STAFF REPORT

TO: Planning Commission
FROM: Ken Roberts, Planning Director
AGENDA ITEM: **The Legacy at North Star Second Addition – Easement Vacations and Final Plat and PUD Plans**
REVIEWED BY: Jack Griffin, City Engineer

Subject: Legacy at North Star 2nd Addition – 74 Lots – Final Plat Narrative

To: Ken Roberts, Planning Director	Re: Legacy at Northstar 2nd Addition – Final Plat
Cc: Chad Isakson, P.E., Assistant City Engineer	Engineering Review Comments
From: Jack Griffin, P.E., City Engineer

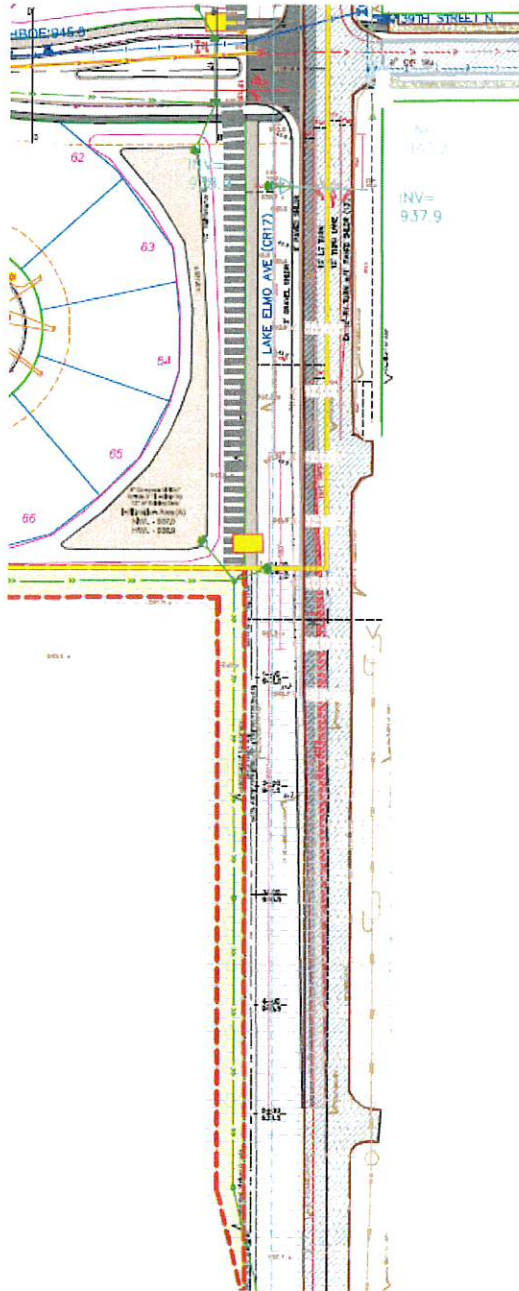
Trails. It was a condition of preliminary plat approval that the applicant provide a trail connection to the Hamlet on Sunfish Lake trails plat, as shown below. This trail connection runs along 39th Street and will connect the Hamlet on Sunfish Lake trails to Lake Elmo Avenue. The applicant and City have worked with the Hamlet on Sunfish Lake residents to determine this connection point. These trails are still private and it is unknown whether or not these trails will be made public.

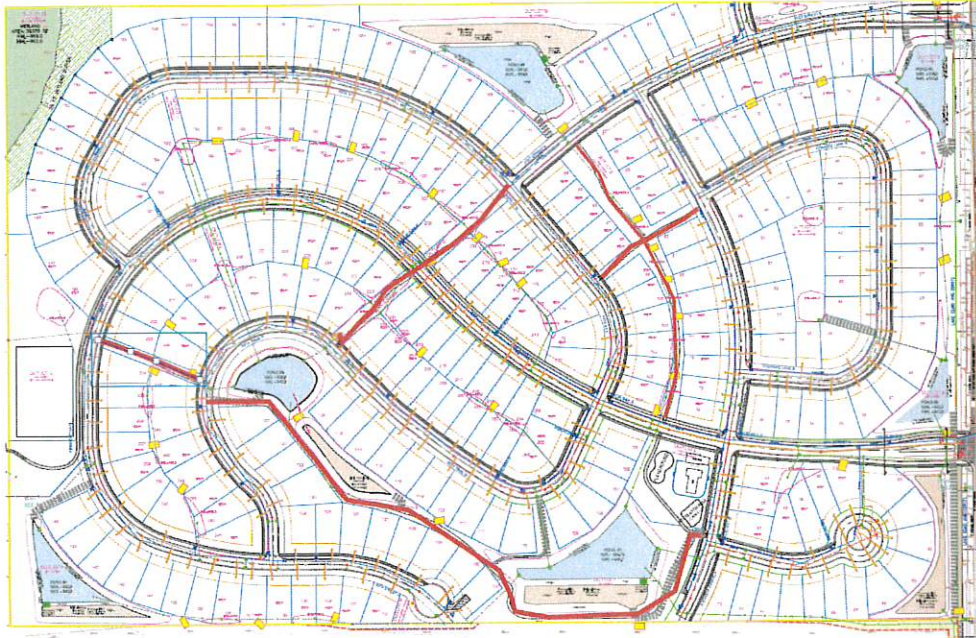
Another condition was that a trail be provided from 39th Street to the southern limits of the plat and that the future County right-of-way area along Lake Elmo Avenue of the parcel to the south of the plat be graded for a future bituminous trail extension (grade ready trail) along the storm sewer outfall pipe location.

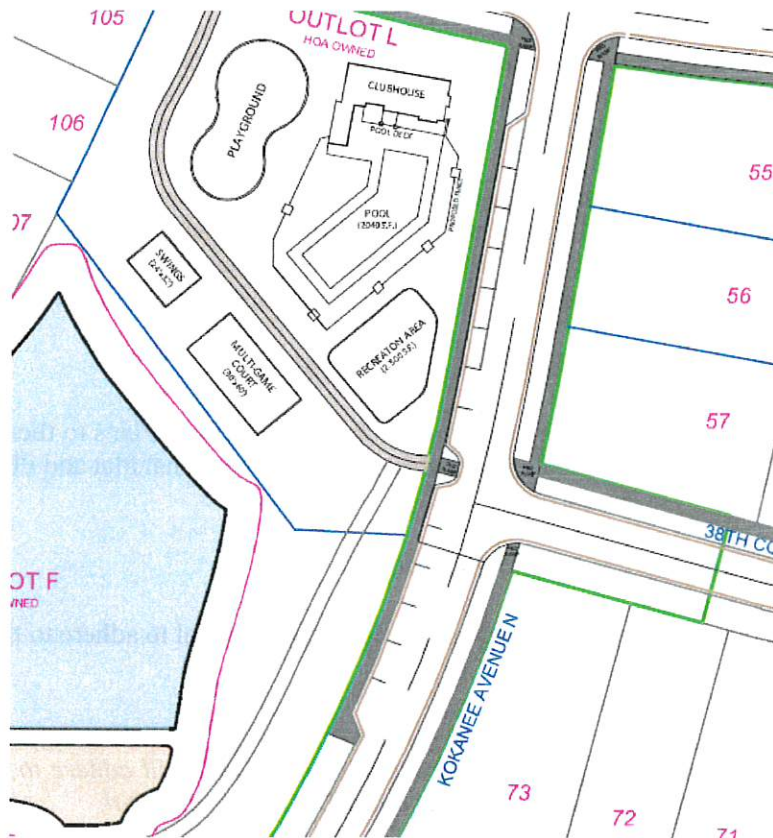
13. *That wetlands and wetland buffer areas be contained within outlots outside of lot areas and dedicated to the City.*

The preliminary plat shows that with buffer averaging this wetland buffer has been contained within Outlot N of the preliminary plat. This condition is not applicable to the Second Addition.
